Comments on Proposed Interim Remedial Action Plan
at Public Hearing on Hillside 881

November 9, 1989

Kim R. Grice

Table X. Surface Soil Analysis: off-site contours.

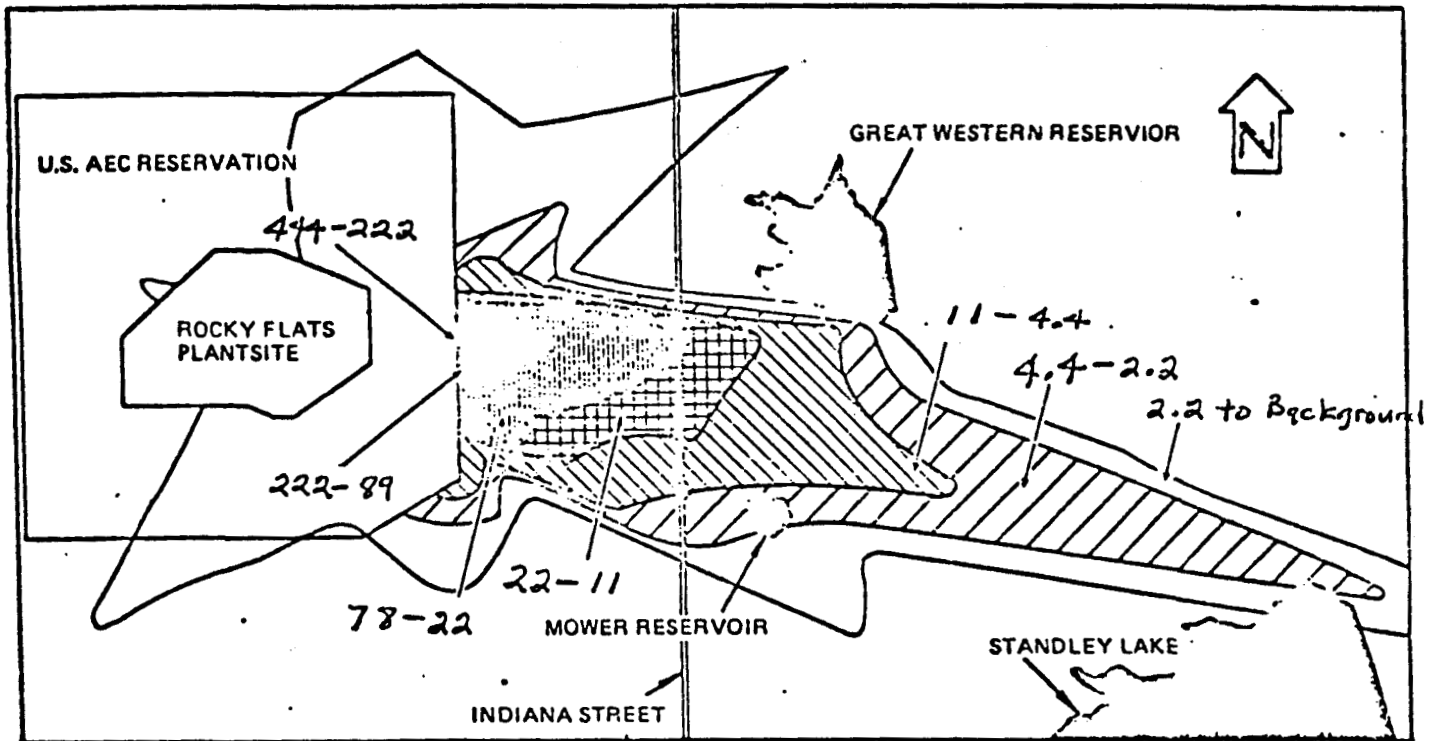
* THIS DOW DOCUMENT SHOWS DEFINITELY THAT RFP CONTAMINATION IS OFFSIGHT, HAS SPREAD SIGNIFICANTLY.
